Grimes City Council Agenda

Topic: Grimes City Council February 23, 2021

- A. Public Hearing and First Reading of Ordinance 747 Rezoning of Property at SE 19th and James Street
- B. Public Hearing and First Reading of Ordinance 748 2018 Building and Fire Code Adoption
- C. Approval of Site Plan – 1861 SE Princeton Drive

UTILITY PLAN

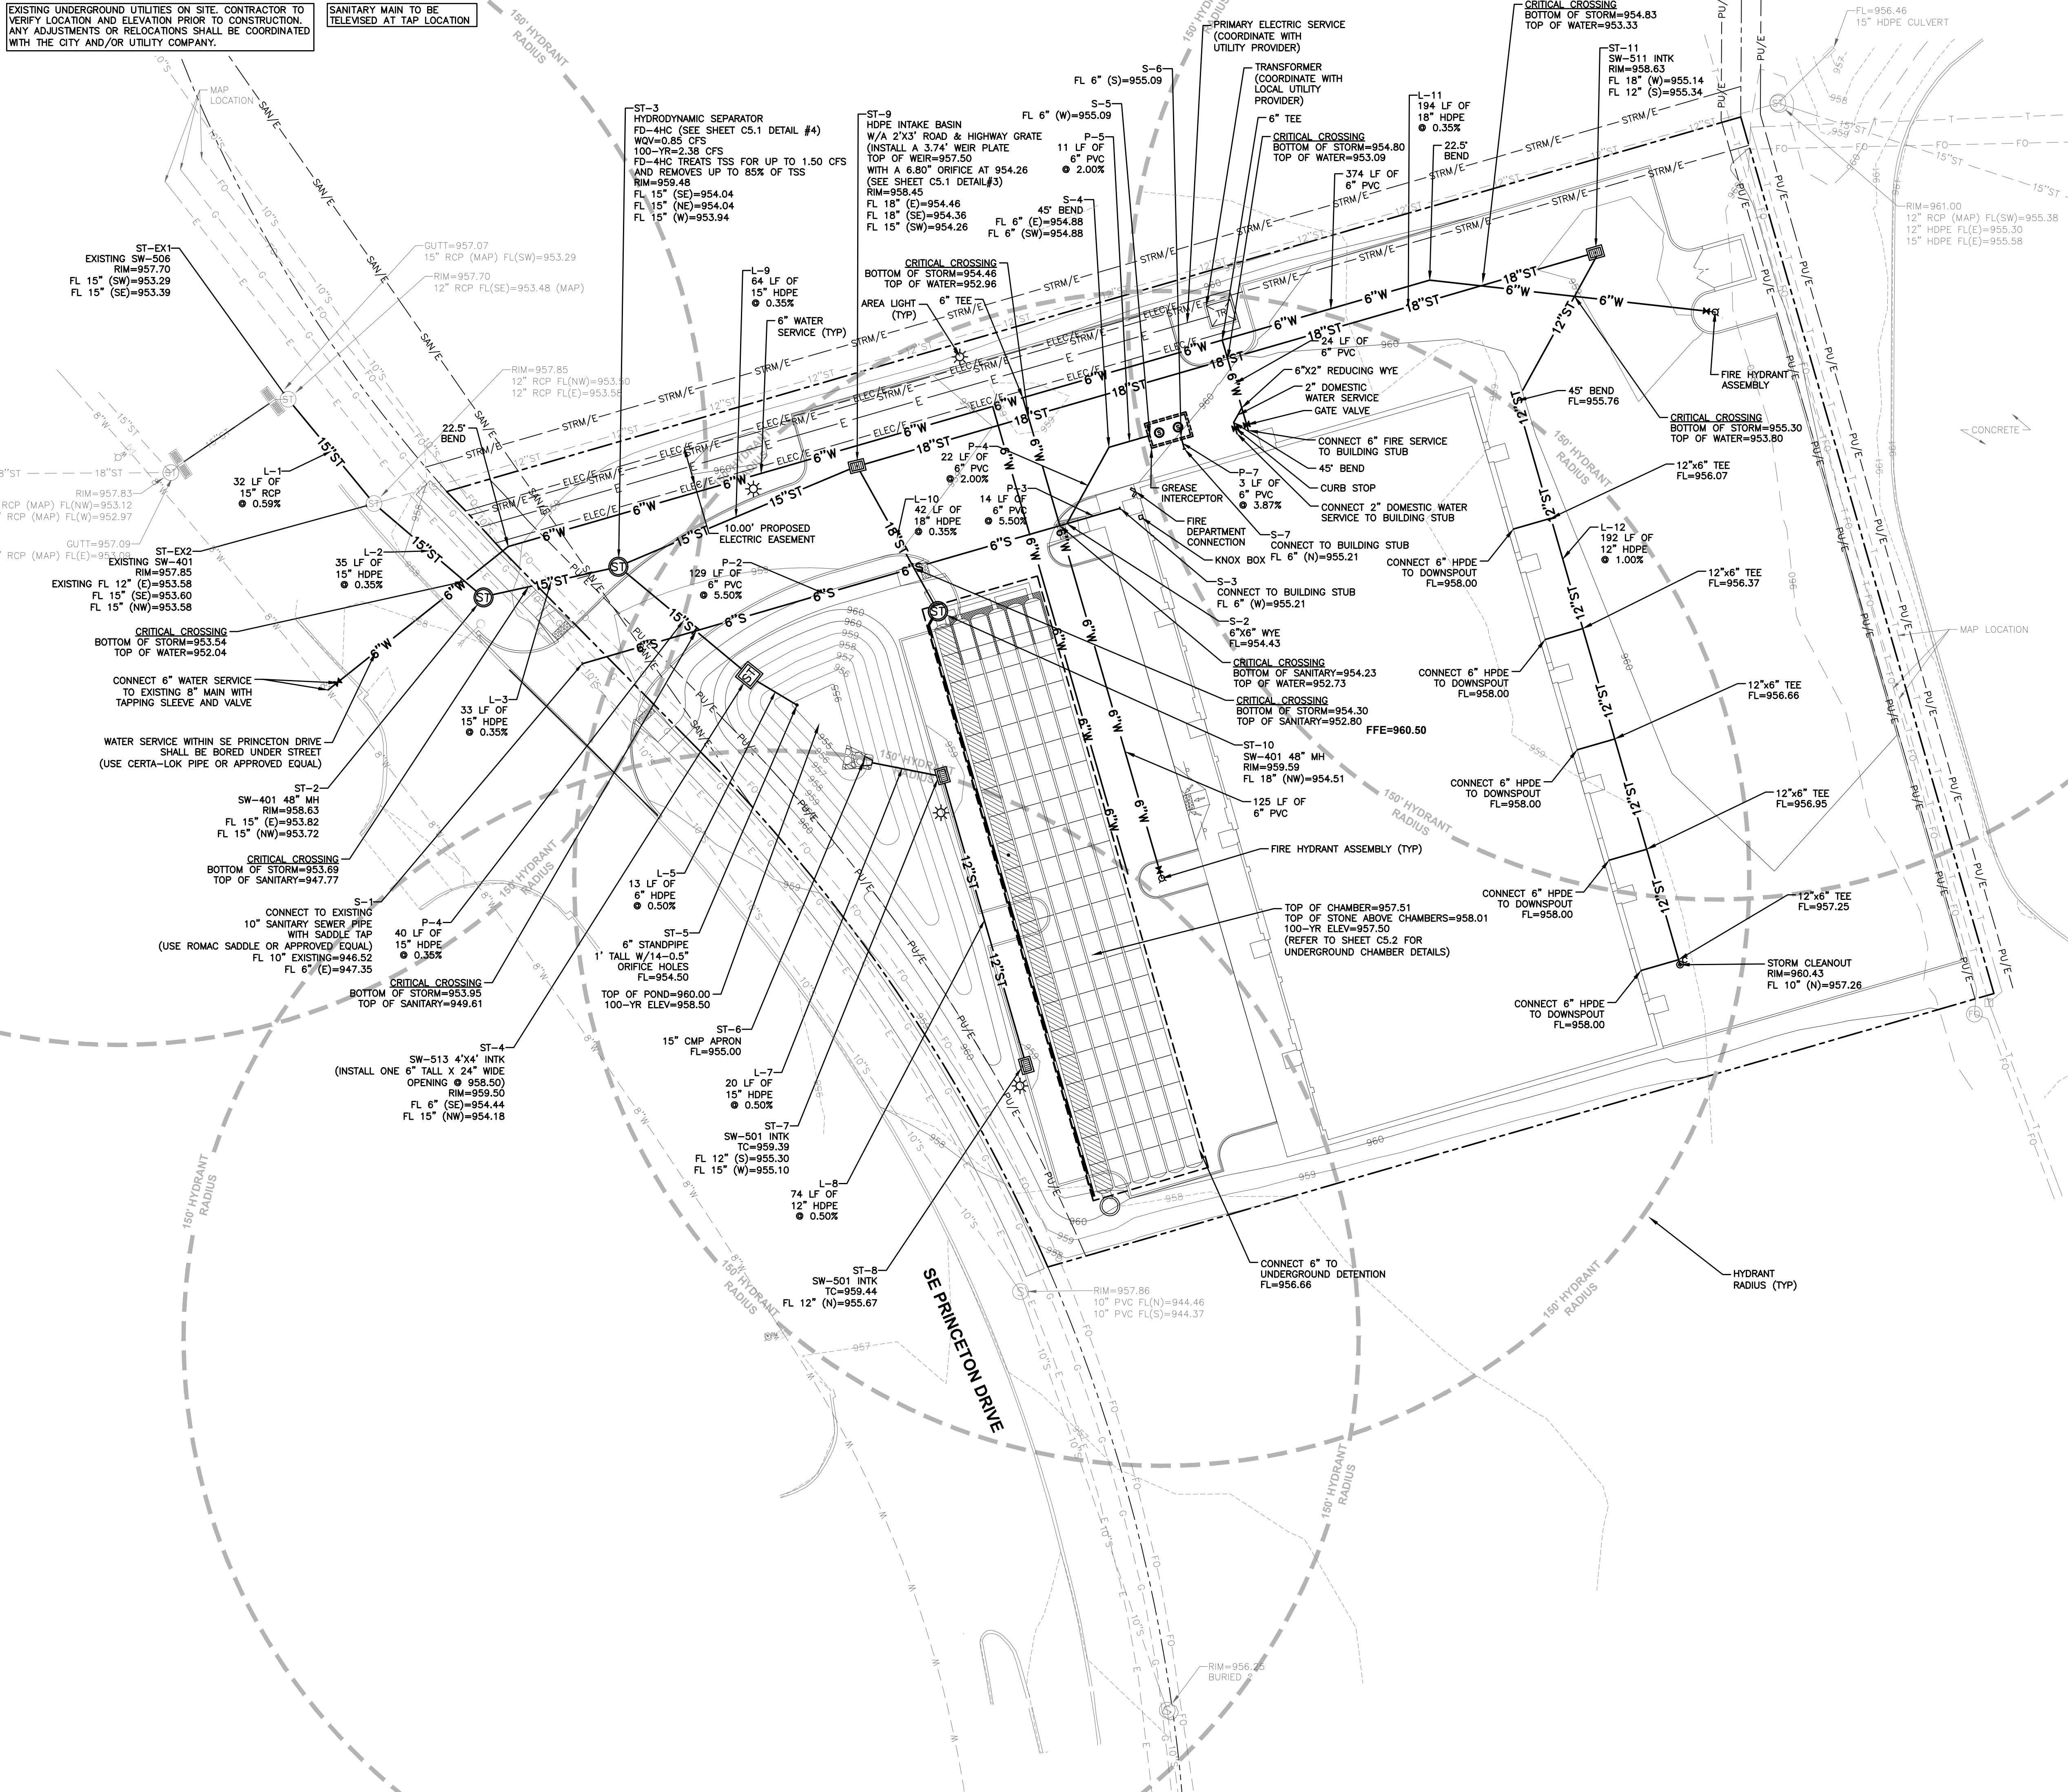
- ~~1. Sheet C4.1: Provide WQv and 100-yr flowrates for the Hydrodynamic separator, and specify 80% TSS removal for WQv flowrate.~~
- ~~2. Sheet C4.1: You cannot use a reducing tee on storm sewer. Provide a structure at the intersection of L-12 and L-11.~~

- ~~3. Sheet C4.1: Provide details for the underground storage. Size of chambers, isolator row, what is the perforated line on the west side of the chambers, typical cross section....~~

- ~~4. Sheet C4.1: Provide details on ST-9. Where is the weir wall placed in relation to all of the connected pipes?~~
- ~~5. Sheet C4.1: Provide details on ST-5.~~

- ~~6. Sheet C2.1: As per detail 3 on sheet C5.1, envelop ST-9 in 8" PCC. 8" PCC is only around half of it.~~
- ~~7. Sheet C4.1: Critical crossing information on L-11 is off the page.~~

- ~~8. Sheet C4.1: ST-4, RIM elevation is the same height as the top of the 6" opening. How is this going to work?~~
- ~~9. Sheet C4.1: Provide WQv and 100-yr flowrates for the Hydrodynamic separator, and specify 80% TSS removal for WQv flowrate.~~

- ~~10. Sheet C4.1: Provide callout to see sheet C5.2 for chamber details.~~
- ~~11. Sheet C4.1: Provide details on ST-9. Where is the weir wall placed in relation to all of the connected pipes?~~
